ECE/TRANS/WP.29/GRE/2009/58
14 July 2009

REGULATION No. 99
(Gas-discharge light sources)

Proposal for draft Supplement 6 to the original version of Regulation No. 99

Submitted by the expert from the Working Party "Brussels 1952" */

Figure 6
Maximum lamp outline 2/

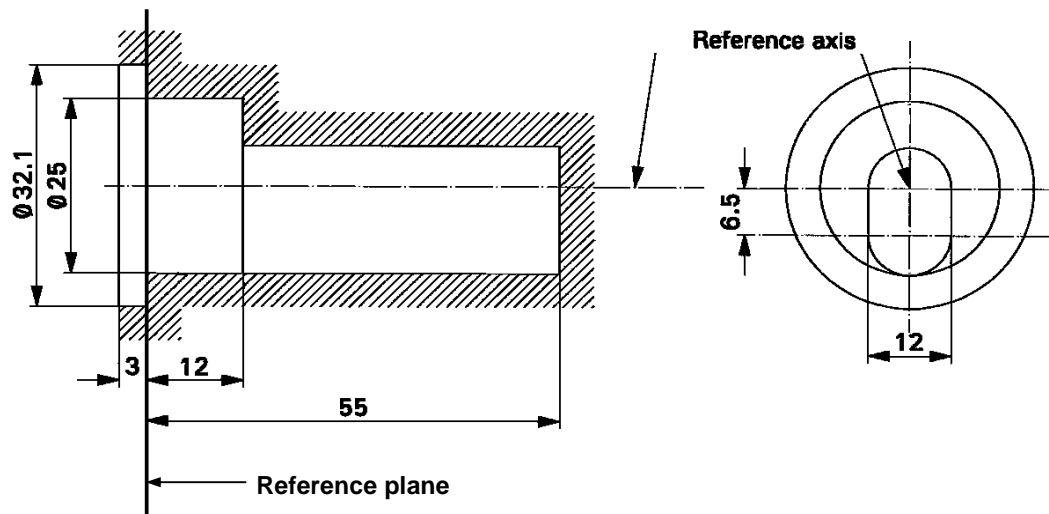
The position and dimension of the maximum lamp outline should be specified with respect to the reference axis and the reference plane. In figures 6 of sheets DxR/3 and DxS/3, the reference plane is missing. Accordingly, this is to be corrected.

- 1/ The reference axis is perpendicular to the reference plane and crosses the intersection of the two parallel lines as indicated in figure 5.
- 2/ Glass bulb and supports shall not exceed the envelope, as indicated in figure 6. The envelope is concentric with the reference axis.

Position and form of the arc

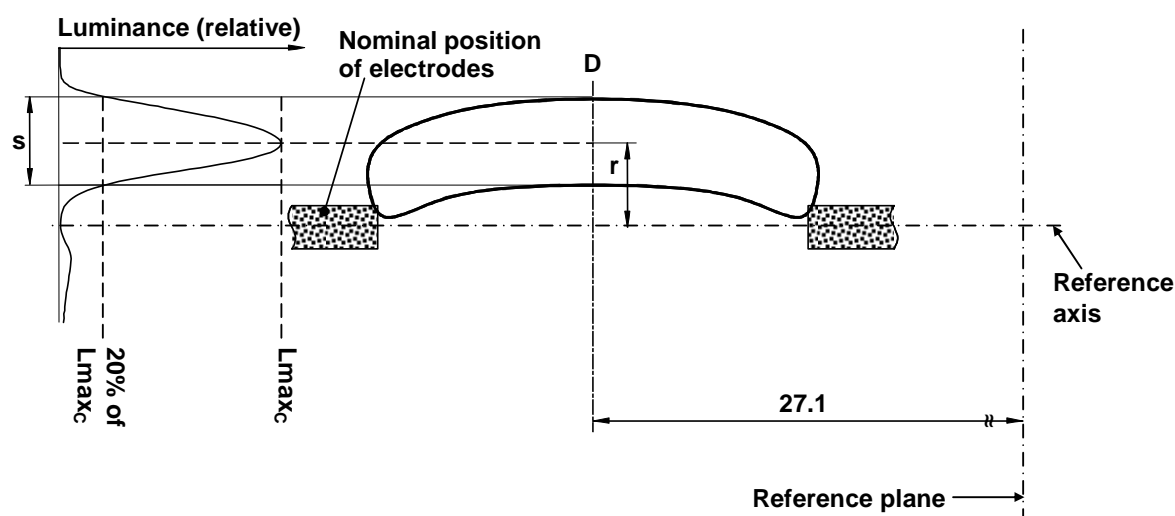
The position and form of the arc of gas discharge light sources D1R, D2R, D3R and D4R shall be measured as prescribed on sheet DxR/6. The drawing on this sheet shows the reference plane on the left-hand side. This drawing should be mirrored.

Moreover, Lmax is currently not clearly defined. It is proposed to measure arc bending and arc diffusion in the central cross section D by "Lmax_C" in viewing direction C and to measure unwanted stray light in Zone A, Line B and C by "Lmax_B" in viewing direction B. The measuring directions have been clarified as well.

When measuring the relative luminance distribution in the central cross section D as indicated in the drawing above, the maximum value L_{max_C} has the distance r from the reference axis. The points of 20% of L_{max_C} have the distance s, as shown in the drawing above.

Dimension in mm	Production light sources		Standard light sources
	D1R/D2R	D3R/D4R	
r (arc bending)	0.50 ± 0.25	0.50 ± 0.25	0.50 ± 0.20
s (arc diffusion)	1.10 ± 0.25	1.10 + 0.25/-0.40	1.10 ± 0.25

Position and form of the arc

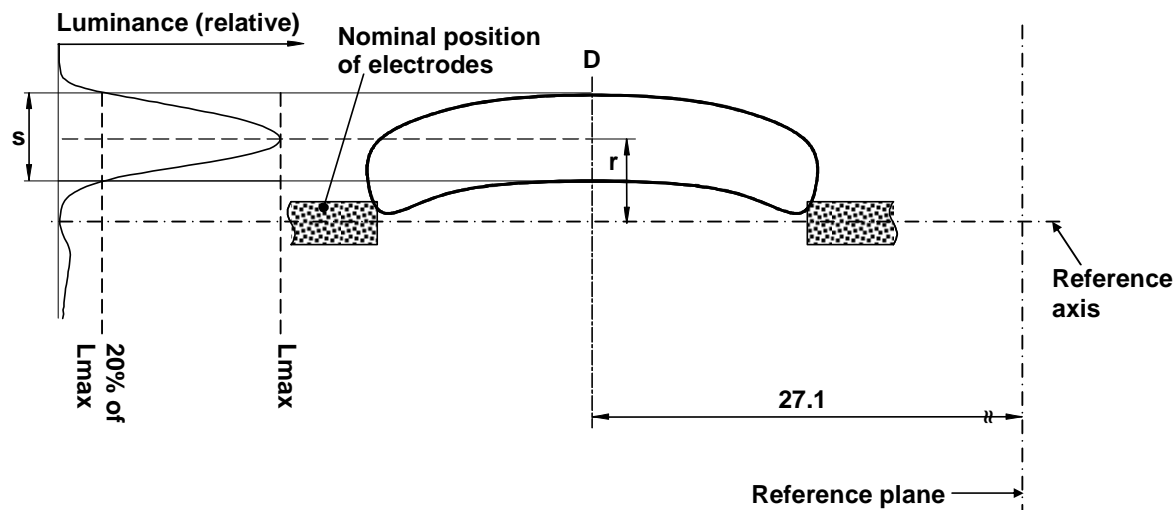
For consistency reasons, similar changes are proposed for gas discharge light sources D1S, D2S, D3S and D4S, as far as applicable (black stripes, unwanted reflected stray light only for "R"-categories).

When measuring the relative luminance distribution in the central cross section as indicated in the drawing above, the maximum value shall be located within the distance r from the reference axis. The point of 20% of the maximum value shall be within s:

Dimension in mm	Production light sources	Standard light sources
r (arc bending)	0.50 ± 0.40	0.50 ± 0.20
s (arc diffusion)	1.10 ± 0.40	1.10 ± 0.25
